**RE: OUTSTANDING MATTERS RESPONSE: 17 REGINA STREET, STONES CORNER  
APPLICATION NUMBER – A006130292**

**INFORMATION REQUEST RESPONSE**

**Lot size and scale:**

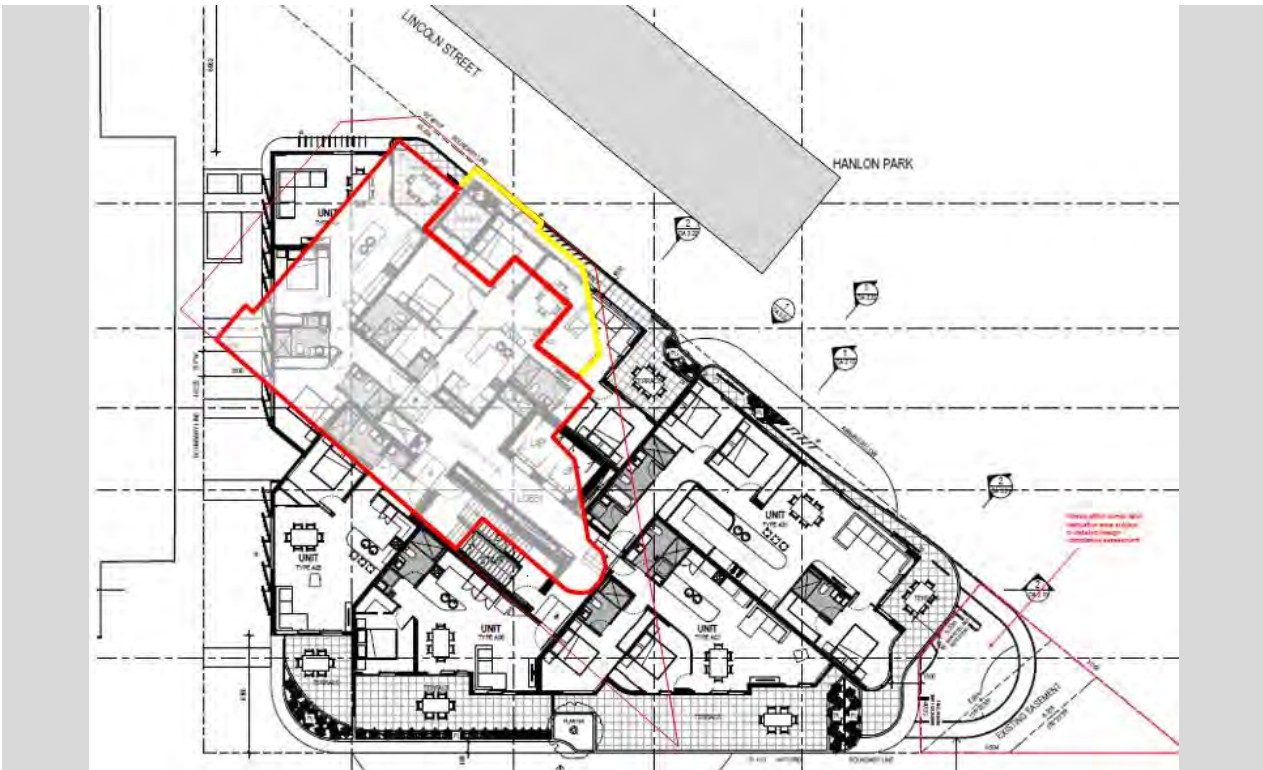
- a) *An increased front setback in accordance with PO5 of the Eastern corridor neighbourhood code;*
- b) *Reduction in the site cover in accordance with PO5 of the Eastern corridor neighbourhood plan code;*
- c) *Reduction in the height of the built to boundary wall in accordance with PO7 and PO34 of the Multiple Dwelling code;*
- d) *Further articulation by way of panelling, patterning or changes in the texture to break up the visual mass of the blank wall plane on the eastern elevation; and*
- e) *Sections showing the proposed development in context with the adjoining Multiple Dwelling code.*

The subject site is a small lot, with an area of just 400sqm and a maximum width of 16m. The consequence of the small lot size is that the site is 'self-regulating' in terms of the potential scale for a building on the property. The net result is a slender tower with a footprint of only **250sqm** and a maximum length of **23.45m**. This results in a far less dominant structure than that of the larger sites in the locality.

The 8 storey building on the adjoining site has a tower footprint of approximately **860sqm** and a minimum dimension of **28m** (i.e. proposed structure approximately 30% of the footprint of the adjoining building located at 9 Regina Street).

### Screening

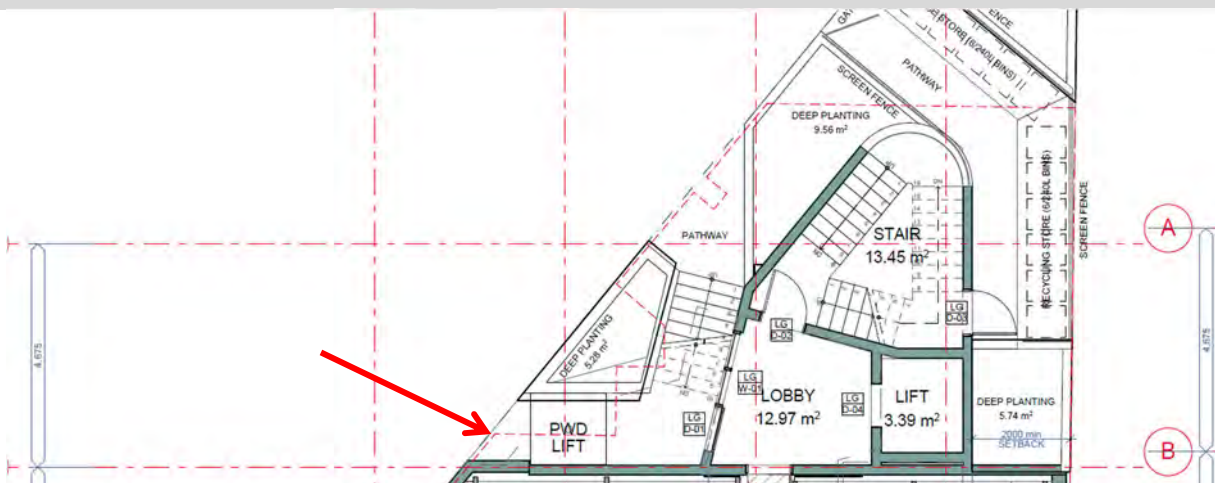
6) Provide amended plans incorporating sun shading devices (screening elements) to the northern and western facing habitable rooms to address PO26 of the Multiple Dwelling code.

The building design has been reviewed to understand the level of solar penetration into the building in the northern and western facades. Shadow diagrams have been prepared to show that the building does not experience excessive solar penetration during the hotter months of the year.

The orientation of the building and large overhangs from the balcony and planter structures ensure that the living spaces are not exposed to significant amounts of direct sunlight, therefore no further screening would be required to protect the internal areas of the building from excessive heat/light.
